Development Services Staff Report

File Number	PL2022-283
File Name	SIGN APPLICATION – Cobey Creek monument signs
Applicant	Clayton Properties Group, Inc.
Property Address	499 and 501 SE M-150 Hwy
Planning Commission Date	October 13, 2022
Heard by	Planning Commission
Analyst	C. Shannon McGuire, Planner
Checked By	Hector Soto, Jr., AICP, Senior Planner

Figure 1. UDO required monument sign measurement area, 188 sq. ft.

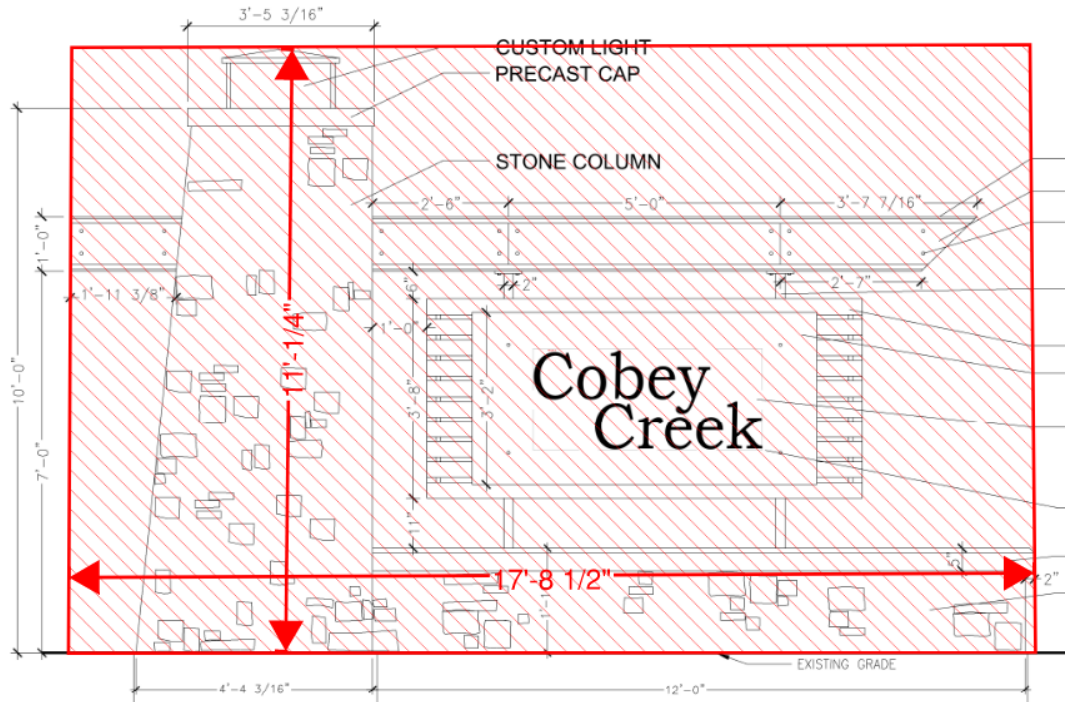
The UDO only provides for a single method when calculating the total monument sign area. For freestanding signs, the sign structure area includes every part of the sign, including the sign area, plus all other elements of the sign, including supports, uprights, base, frame, decorative and design elements, and any open space contained within the limits of the rectangle delimiting the sign structure. Simply put, the UDO requires the area of a sign be calculated as Height x Width, (Figure 1). While this is an effective method for calculating the total sign area of rectangular shaped signs, it is an overly simplistic method when trying to calculate the total area of signs with an irregular shape. Using this method of measurement, the proposed signs are each 92 sq. ft. over the UDO standards.

Figure 2. Actual monument sign structure area, 104.98 sq. ft.

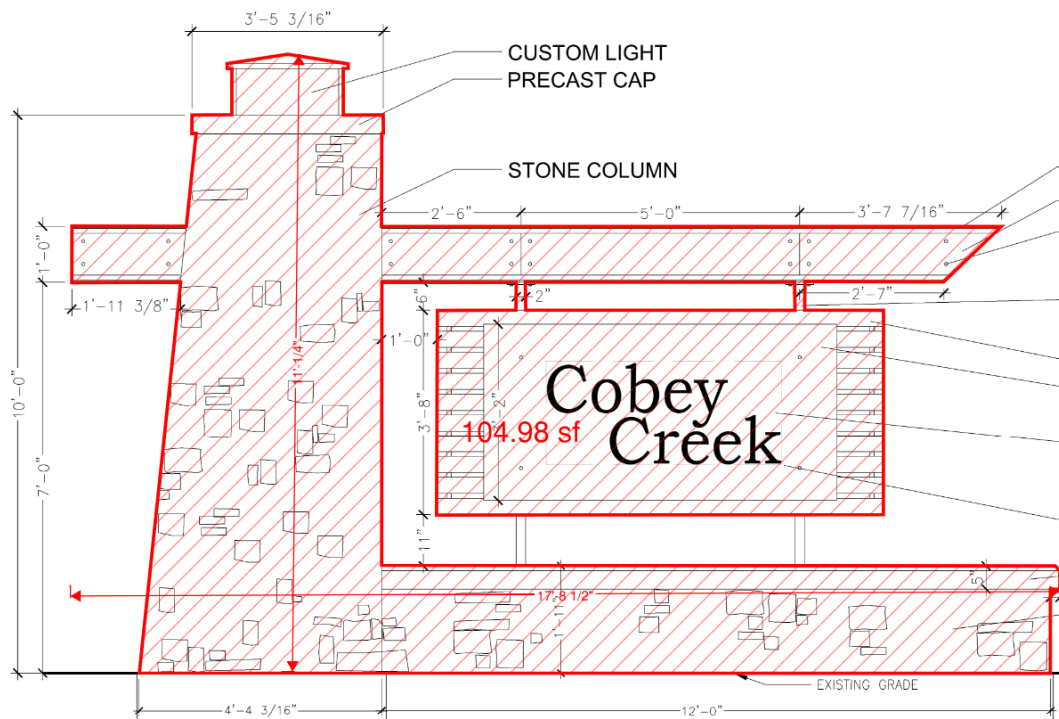
Utilizing the Revu Bluebeam software package, staff can calculate the actual sign face area. This method provides for an accurate calculation of what is being proposed. In this case, the proposed monument signs each have a total sign structure area of roughly 105 sq. ft. (Figure 2). Using this method of measurement, the proposed signs are only slightly larger (9 sq. ft) then what the UDO allows by right.

By using the second method of calculating the sign structure area, the applicant can propose a sign that provides an elevated architectural appearance without being penalized by the simplistic measurement method found in the UDO. Staff believes the proposed monument signs meet the intent of the UDO. For the above stated rationale, staff believes the proposed signs are reasonable and supports the applicant's request. With the conditions of approval below, the application meets the requirements of the UDO.

1. Four (4) 188 sq. ft. monument signs shall be allowed, as depicted on the sign elevations and site plan sheets, dated September 8, 2022, for Cobey Creek located at 499 & 501 SE MO-150 Hwy. Signage shall comply with all other UDO sign standards of the PMIX zoning district.
